RE: Addendum to the Water Management Plan and Borrow Pits and Quarries Management Plan

Project Name:	Meliadine Gold Project	
Plan / Version:	Water Management Plan	June 2016, Version 2
NIRB Requirement:	Not applicable	Condition: Not applicable
NWB Requirement:	2AM-MEL1631	Condition: Part B, Item 12
Addendum:	Version 3; October 2016	
Section Change	Specify: Update or New	Details
Figure 3.1	Update	Addition of ponds H17 A, B and C
Table 4.1	Update	Addition of ponds H17 A, B and C

Project Name:	Meliadine Gold Project	
Plan / Version:	Borrow Pit and Quarries Management Plan	April 2015, Version 4
NIRB Requirement:	Not applicable	Condition: Not applicable
NWB Requirement:	2AM-MEL1631	Condition: Part B, Item 12
Addendum:	Version 5; October 2016	
Section Change	Specify: Update or New	Details
Figure 1-1	Update	Addition of Tiriganiaq, Wesmeg, Meliadine esker and B6 borrow pits.
Table 1-1	New	Table added to present approved borrow pits and quarries.
Section 2.2	Update	Updated to clarify interpretation of the 31 m buffer condition and changes in operations.

Figure 2. Extent of the Meliadine Esker

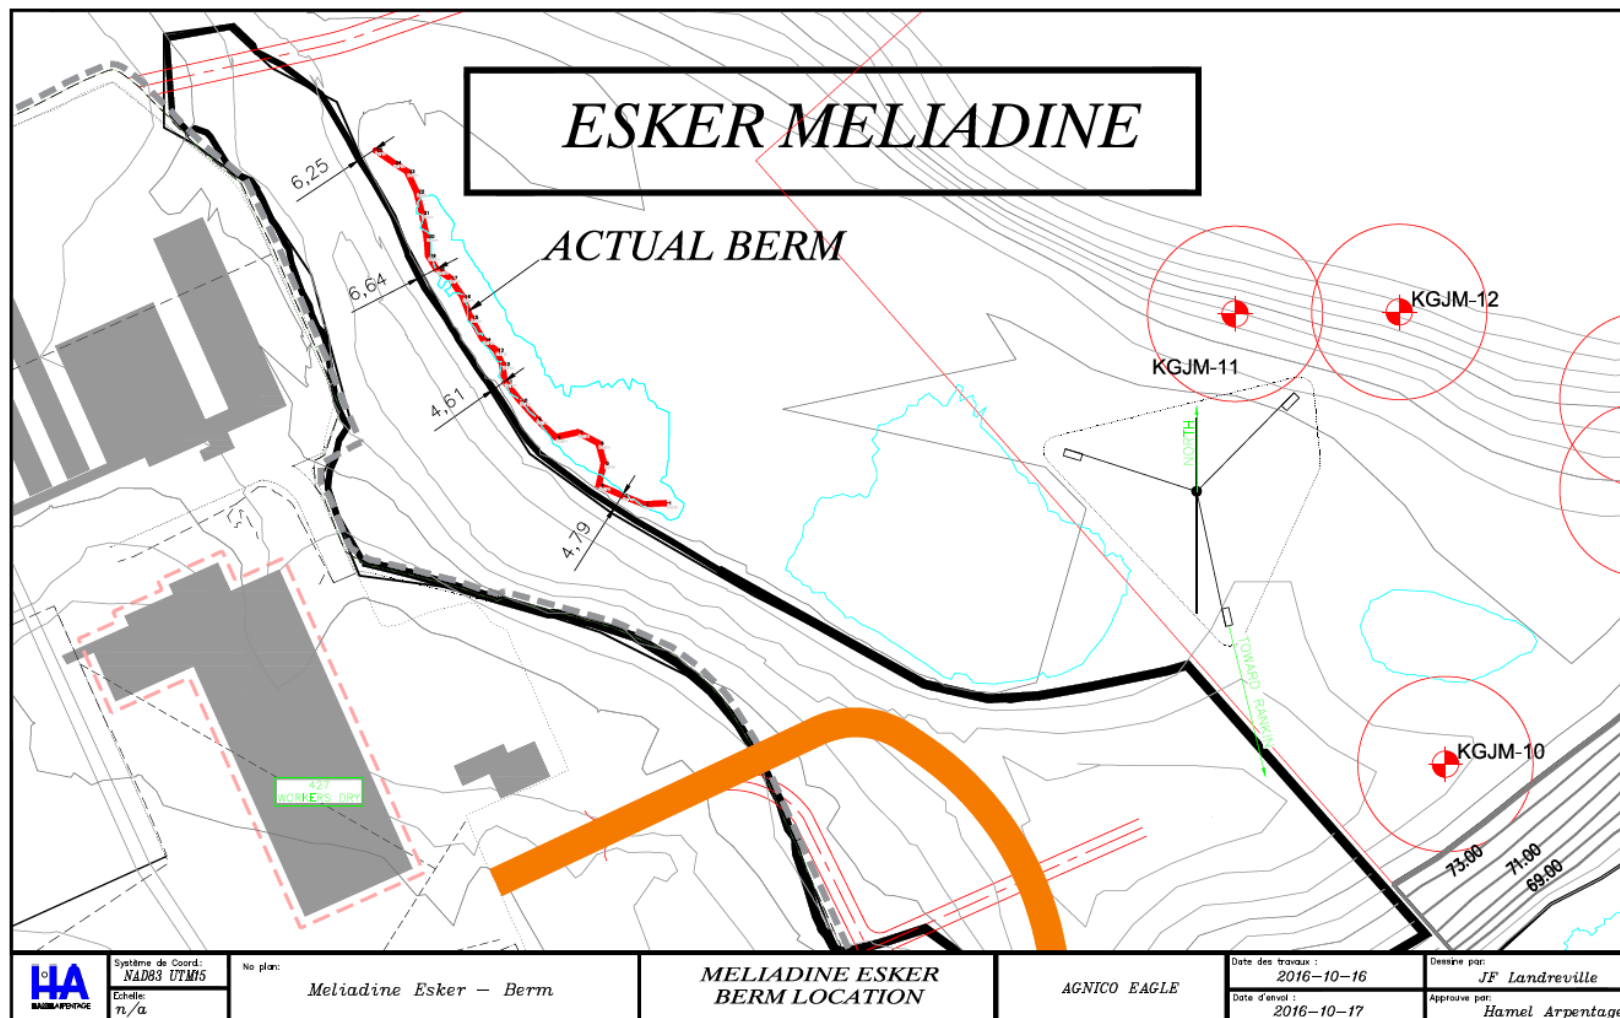
During the extraction of Esker material, it was noted the boundaries of the esker had inadvertently encroached 7m beyond the boundary of the quarry lease and the boundary of excavation was within the 31 meters setback of pond H17C. The extent of the material taken in the Meliadine Esker is illustrated on Figure 2 (Actual Berm).

Agnico Eagle proposes to undertake immediate corrective measures consistent with Part D, Item 20, of our current Water Licence 2AM-MEL1631 to minimize and mitigate potential impacts to ponds H17A, B and C. The scope of the water licence contemplated the drainage of ponds, which is highlighted in footnote 1.¹

Figure 3.1. Yearly Site layout plan for water management (last quarter of Year -5)

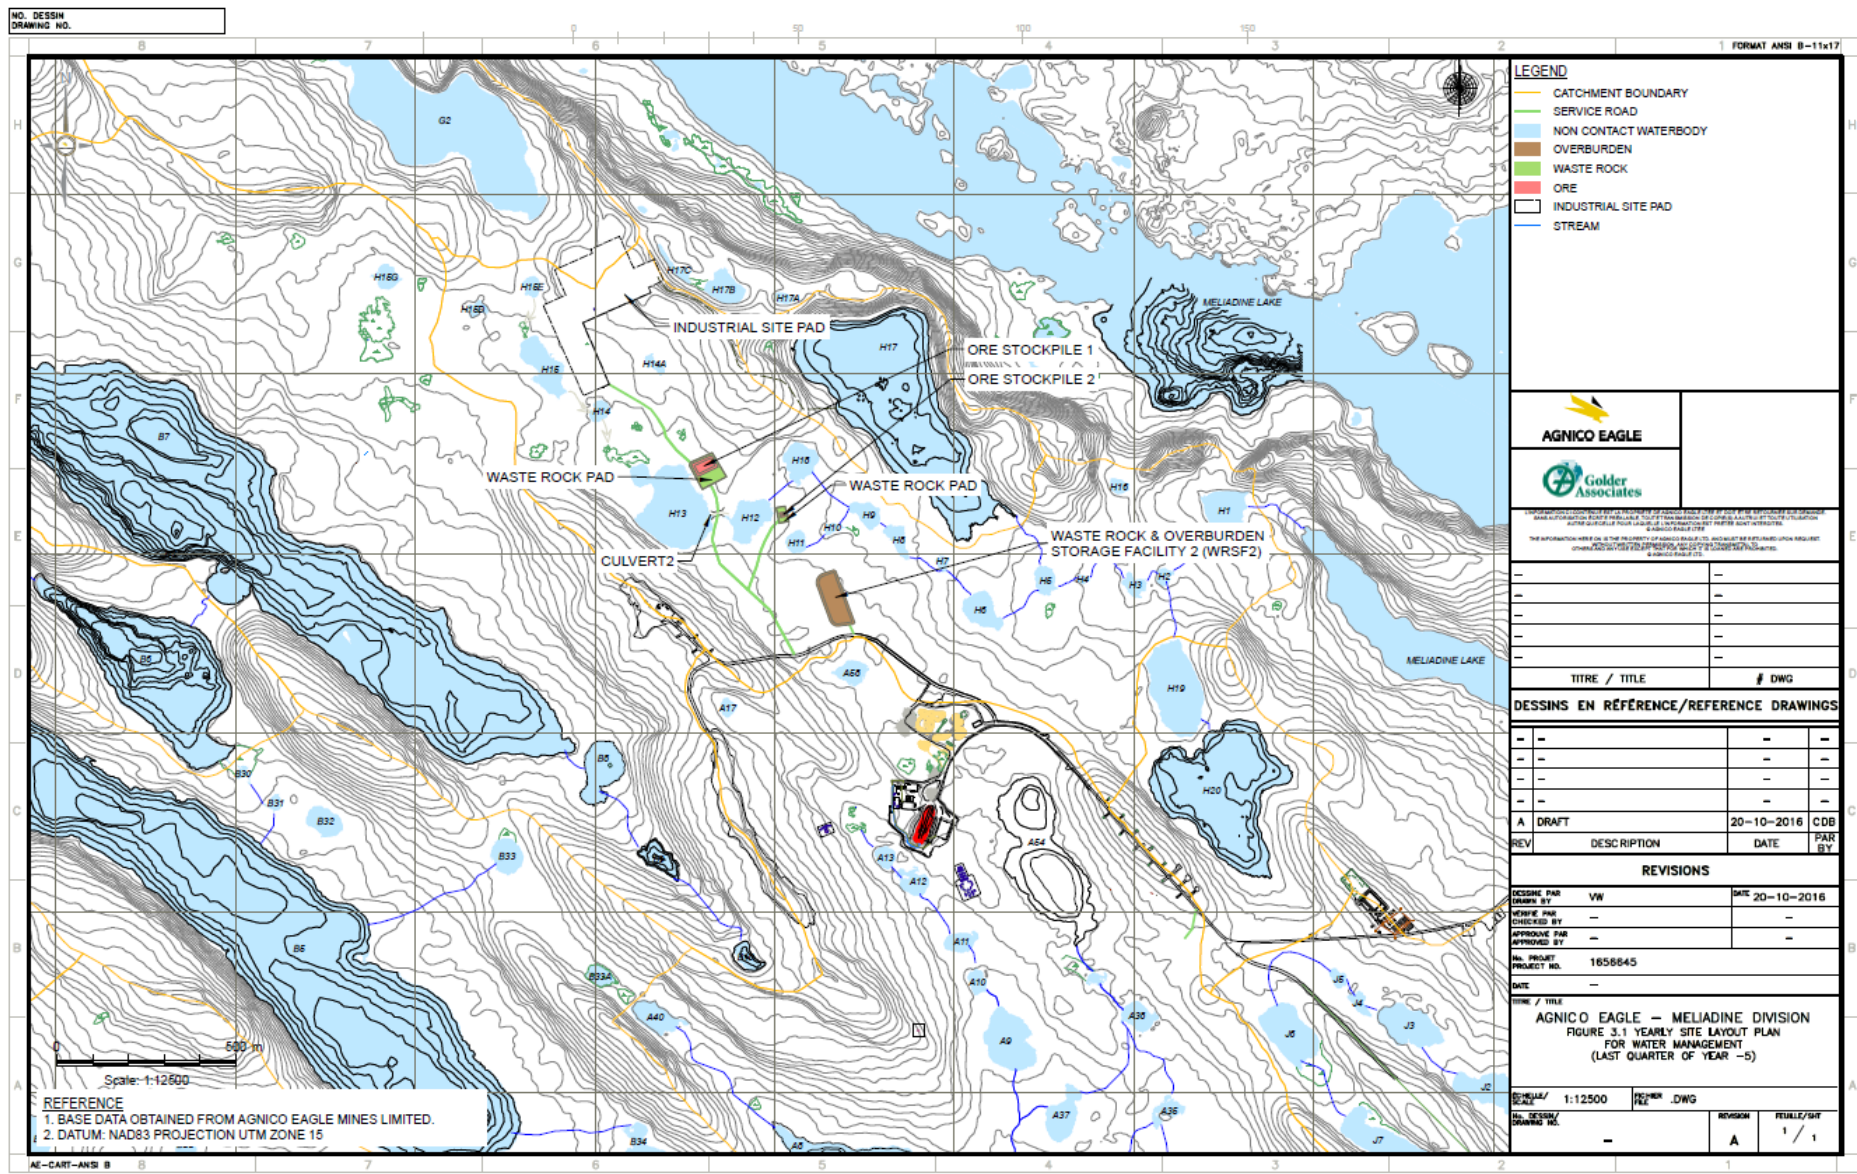
Licence², it was determined that the current plan required some clarification and revision to reflect changes in operations to incorporate design changes and adaptive engineering required and implemented during construction. It was also observed that ponds H17A, B and C were not incorporated to the Plan even though Agnico Eagle assumed that the above-mentioned ponds would be dewatered.

As such, Table 4.1 and Figure 3.1 have been updated to provide clarification in operations. Refer to Appendix A addendum to the Water Management Plan. The approximate water volume to be pumped from ponds H17A, B and C is 15,165 m³ and will not impact CP1 and the water balance.

Figure 1.1. Location of Borrow Pits and Quarries for the Meliadine Gold Project

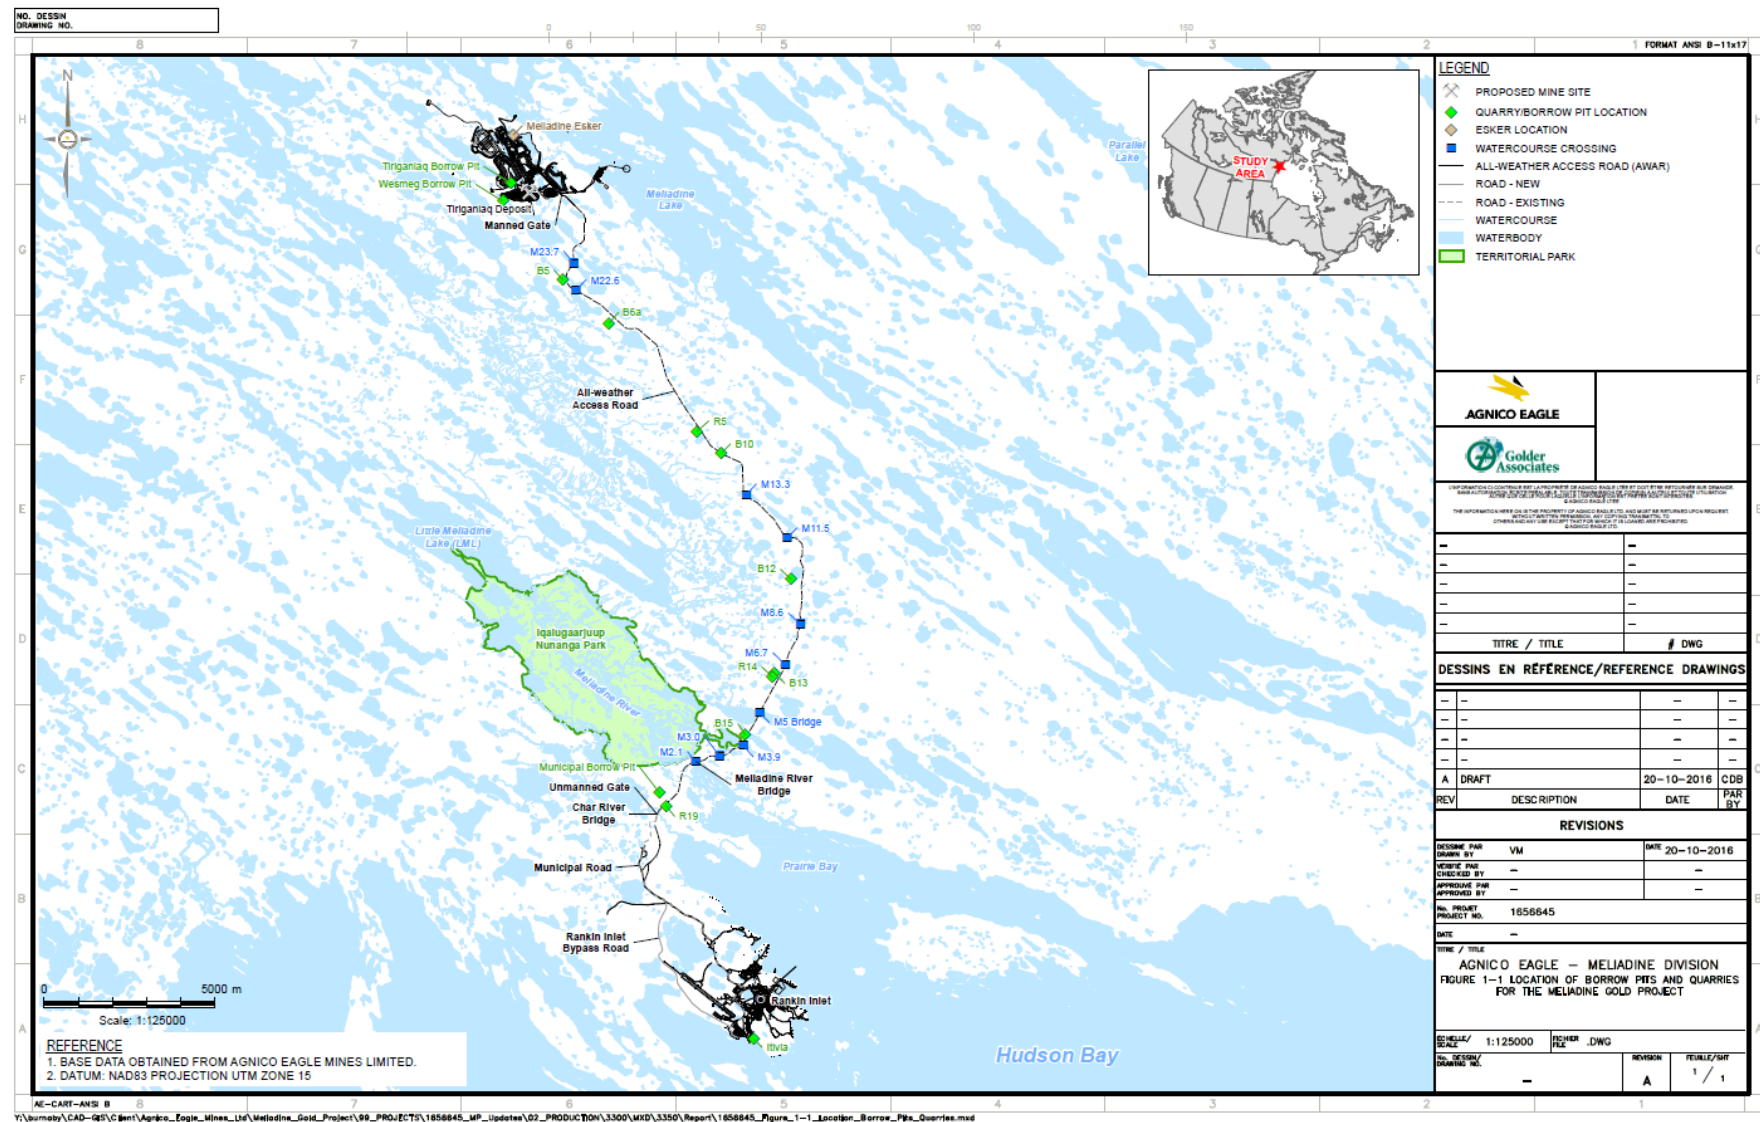
The basis for clarification relates specifically to the sources of esker material for construction purpose. Agnico Eagle consistent with Part B, Item 15 (see footnote 2) has also submitted addendum to the Borrow Pits and Quarries Management Plan, refer to Appendix B. Figure 1-1 have been updated and Table 1-1 has been added to include all currently approved quarries. In addition Section 2.2 was updated to clarify interpretation of the 31 m buffer condition and changes in operations. Further updating of the Borrow Pits and Quarries
